NL-08-0107

Vogtle Electric Generating Plant
License Renewal – Audit Question Responses

VEGP License Renewal Audit Question Responses

Figure 1

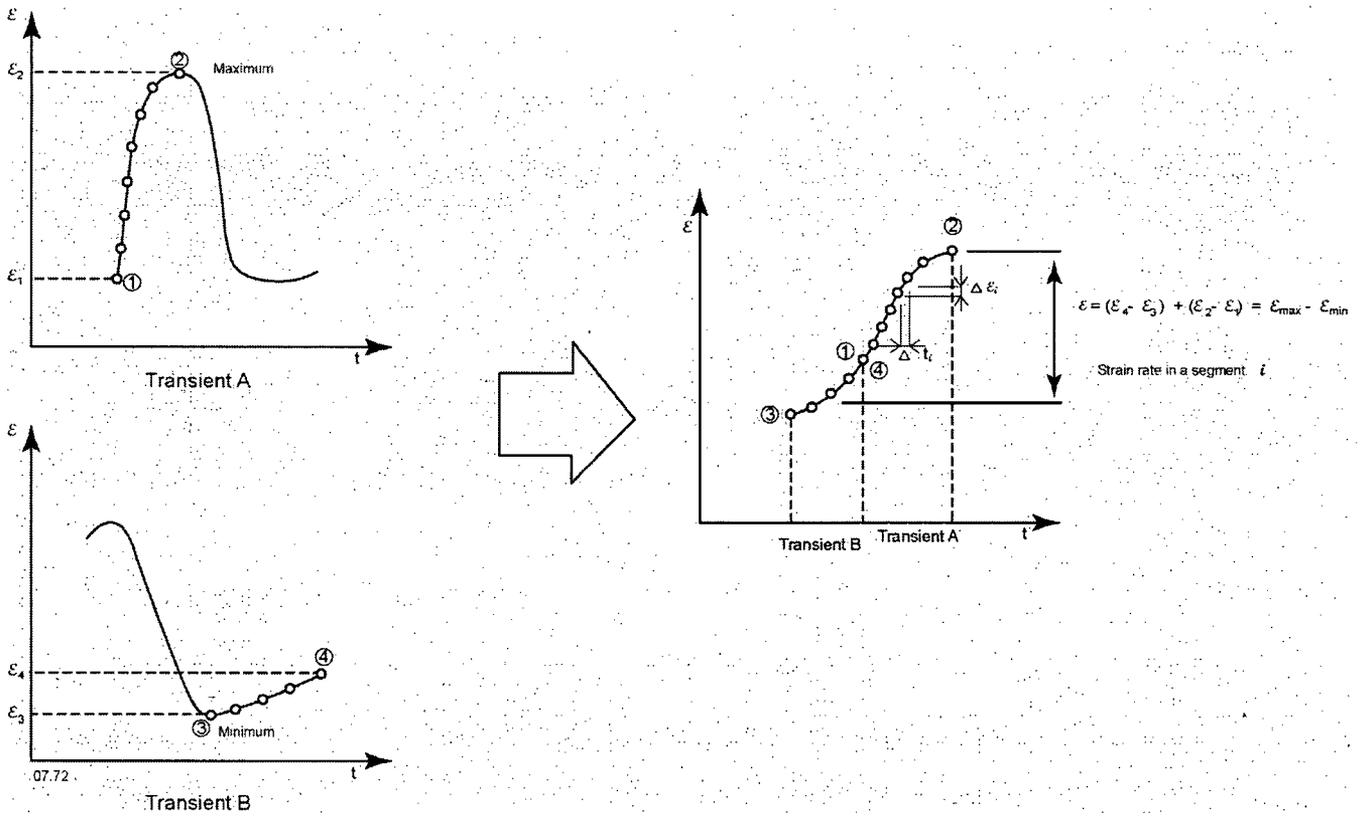
- 2) For the SI nozzle, the basis document (VOG-01Q-301, p19) states that "simulated design basis event expected to be reasonably representative of the actual plant event" and FatiguePro was used to analyze a simulated safety injection event shown on Figure 2. Appendix B provides the analysis using "simulated transient for SI for Millstone-3". Please clarify if the transient shown in the Figure 2 as the input to the analysis for the Fen of SI nozzle.

- 2) Yes, Figure 2 is the basis for the Fen evaluation for the SI Nozzle.
- 3) The Fen calculated was not Millstone's Fen, it was Vogtle's Fen. The Millstone model was used to simulate an event because their plant is also a 4 loop Westinghouse plant of the same vintage as Vogtle with the same nozzle design and the same design transient. The simulated event used the Vogtle ambient containment temperature instead of Millstone's ambient containment temperature.
